**Re: Response to Preliminary Geologic/Seismic Hazard Review and
Supplemental Geologic Investigation
Proposed Senior Housing Facility
4200 Dove Hill Road
San Jose, California
Langan Project No.: 770619902**

This letter presents our response to review comments by the San Jose Department of Public Works (SJDPW) dated 25 September 2015 regarding our Geotechnical Investigation and Geologic Hazard Evaluation report dated 30 June 2015 for the proposed senior Housing Facility project at 4200 Dove Hill Road in San Jose, California. SJDPW had several comments (designated 1 through 13 in their review letter) regarding geologic/seismic hazards evaluation and mitigation at the site; a copy of the review letter is included in Appendix D. The project will consist of two new buildings, designated as Buildings A and B; both buildings are proposed to be four stories above a podium level as shown on Figure 1.

\\snpn.com\user\lsc\lsc\user\770619902_Cross_Sect - 770619902.dwg - Design\Files\Technical\770619902-48-XS0103.dwg 2/24/16

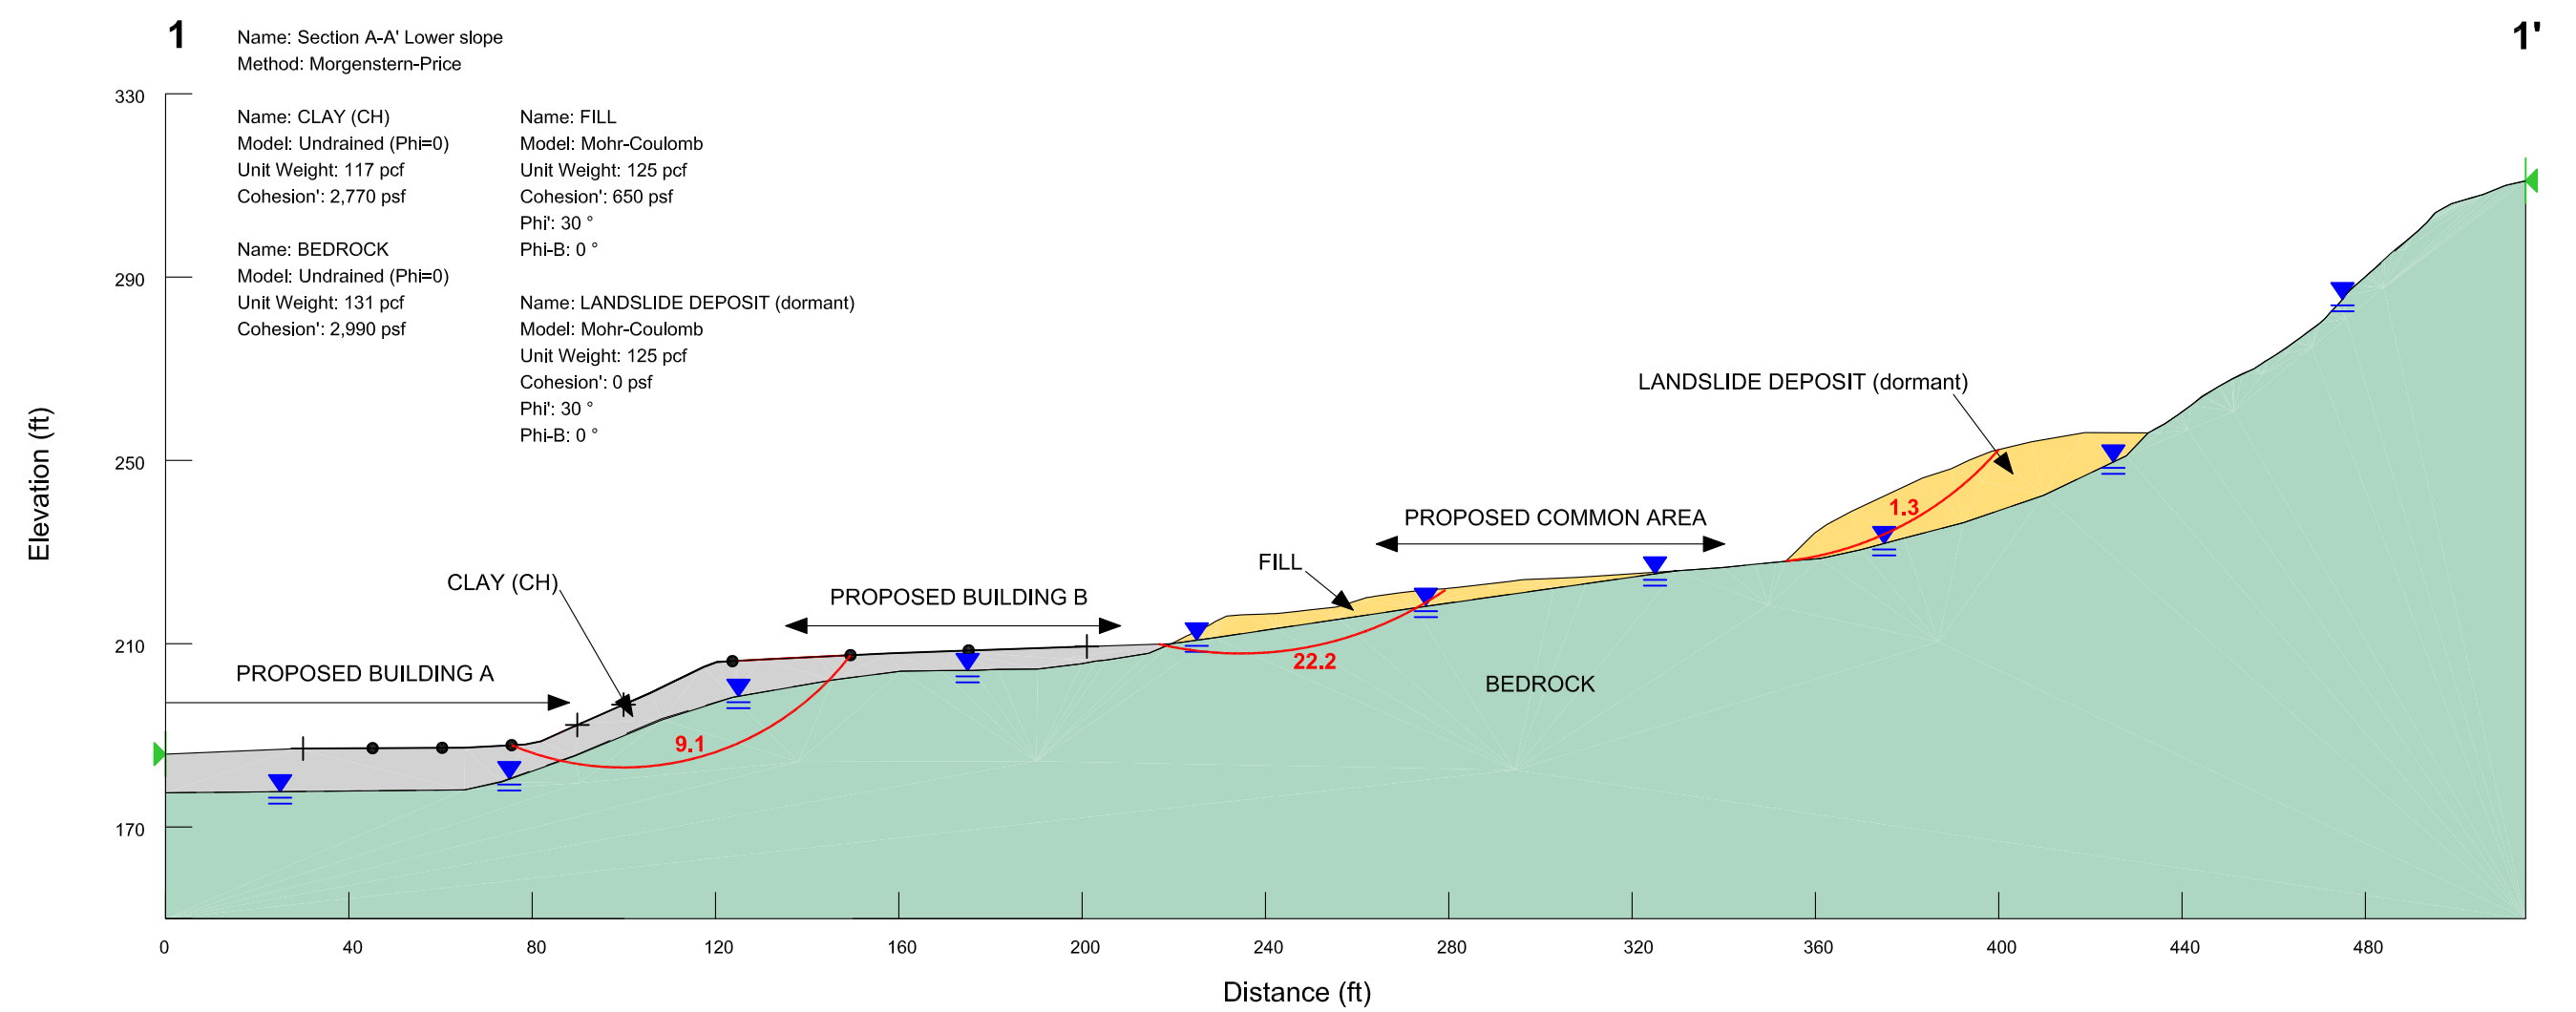
SJDPW was concerned that the existing landslides on the northern and southern slopes of the site could mobilize and impact the proposed development under potential high groundwater seepage conditions. SJDPW requested that the landslides be characterized in greater detail and evaluated under these conditions.

The results of the slope stability analysis of Section 3-3' showed a static factor of safety of less than 1.5 and slope displacement of about 4 inches. SJDPW recommended that the stability of cross section 3-3' be reevaluated based on the supplemental subsurface exploration and potentially high groundwater levels.

We have analyzed the slope stability on the site using the newly acquired data. In our initial evaluation we conservatively modeled the groundwater along the surface of the bedrock, however we did not portray this on our figures. The location of the critical slope failure surfaces and the location of the modeled groundwater surface for each of the profiles evaluated are provided on Figures 4 (current conditions) and 5 (proposed grading)/.

The results of our analyses indicate most of the existing slopes are stable or may exhibit negligible permanent slope displacements upslope of the proposed improvements during a major earthquake. However, the landslide deposits above proposed Building B could exhibit significant permanent slope displacements, if not removed and regraded, as previously discussed. The results of our slope stability analyses and seismic slope displacements are summarized in Table 2, below for existing conditions. We used the same methodology to evaluate slope stability and potential slope deformations during a seismic event as discussed in our previous geotechnical report. The location of the critical slope failure surfaces for each of the profiles evaluated showing existing conditions are provided on Figure 4.

See response to comments 1 and 4 for additional details concerning the supplemental subsurface exploration, groundwater conditions, and results of the slope stability analyses. The location of the critical slope failure surfaces and the location of the modeled groundwater surface for section 3-3' are provided Figures 4 and 5.
